**star bulletin**

Date: December 22, 2005  
Order No.: P-B-15.30/55a  
Supersedes: P-B-15.30/55 dated August 24, 2005  
Group: 15

**SUBJECT: Model 203.040/052/054/056/061/064/065/076/081/084/087/092/261/264/281/284/740/747/764  
All Model Years  
Engine Not Starting / Starter Fuse Malfunctioning**

Figure 1

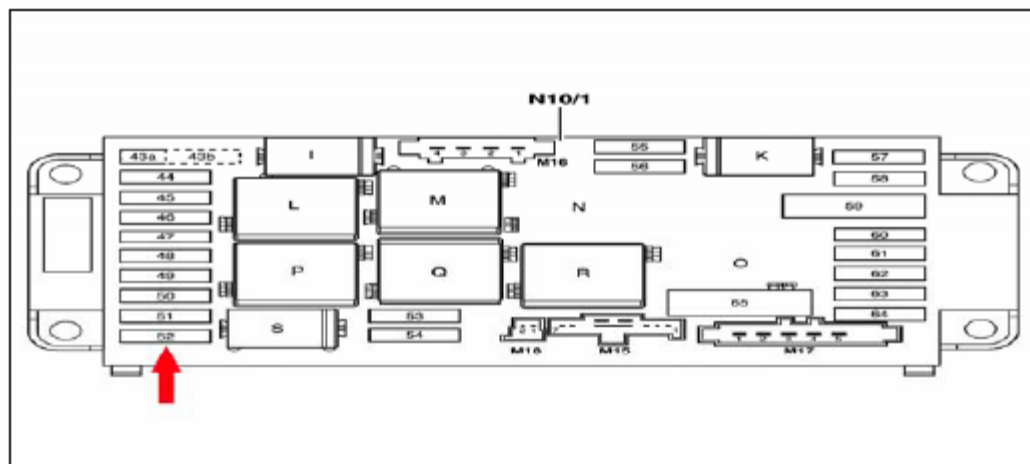
If you receive customer reports in the above model vehicles of the engine not starting, the Starter Fuse in the Driver Signal Acquisition and Actuation Module (SAM) may be malfunctioning. The Driver SAM should be fitted with a larger 20 Amp fuse.

1. Perform a visual inspection of the Driver SAM (N10/1) and determine which fuse is installed in socket 52 (Figure 1, arrow). Consult STAR Finder for more information on the location of this fuse (10/1f52).
2. Replace the currently installed 15 Amp fuse with the 20 Amp fuse specified in this DTB.
3. Record the fuse rating change on the vehicle's Fuse Chart.

Qty.	Part Name	Part Number
1	Fuse 20A	N072581 000306
